Agenda
HAILEY PLANNING & ZONING COMMISSION
Monday, July 20, 2020
Virtual Meeting
5:30 p.m.

FINDINGS OF FACT, CONCLUSIONS OF LAW AND DECISION

STAFF REPORT
Hailey Planning and Zoning Commission
Regular Meeting of June 15, 2020

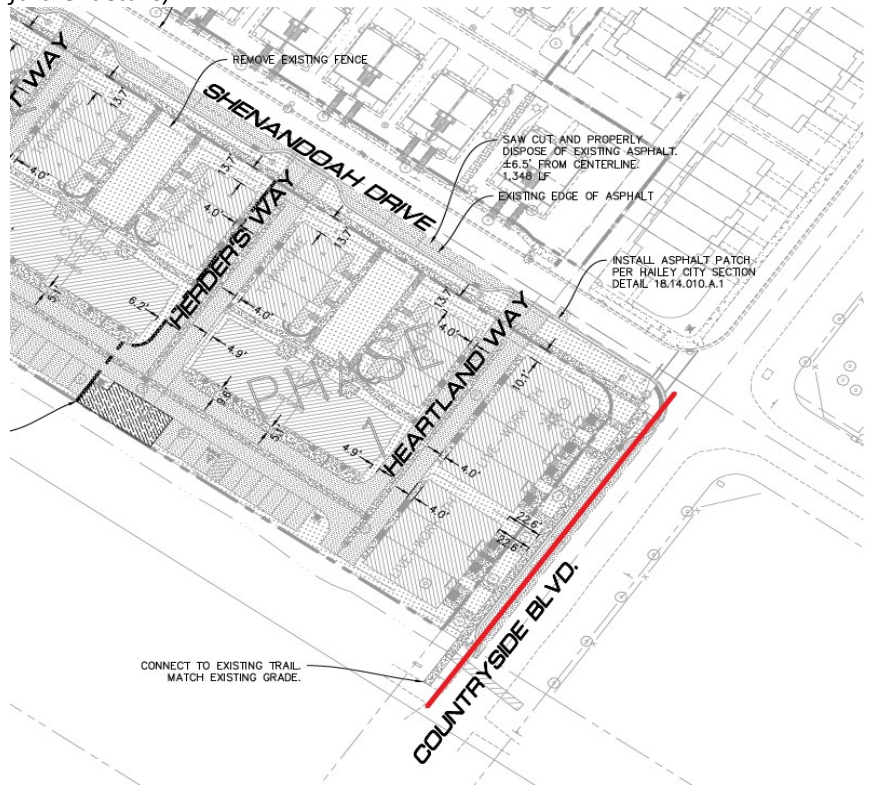
Staff Comments	<p><i>The subdivision is located in the Limited Business (LB) Zoning District. Please see Section 16.04.110 for further details.</i></p> <p><i>The Commission has found this standard to be met.</i></p>
<input checked="" type="checkbox"/>	<input type="checkbox"/>	<input type="checkbox"/>	A. 2.	<p>Pathways: The developer of any subdivision, or any part thereof, shall provide pathways for all trails and paths identified in the master plan that are located on the property to be subdivided or on City property adjacent to the property to be subdivided, and sidewalks required by this ordinance.</p>
			Staff Comments	<p><i>A new five (5') foot-wide sidewalk is proposed along the perimeter of the proposed project. This sidewalk will run parallel to Shenandoah Drive, approximately 600' in length, before curving to the east and crossing Shenandoah Drive (continental crosswalk, which utilizes thermoplastic materials). This sidewalk will connect to existing pathways found near and around the park space and amenity building.</i></p> <p><i>Pedestrian connections are also shown at the northwestern end of the parcel, connecting to the Wood River Trail, and from the Wood River Trail to Shenandoah Drive (see image below for further details).</i></p>

A second connection is also proposed from the public sidewalk on the north side of Countryside Boulevard to the Wood River Trail (see image below for further details).
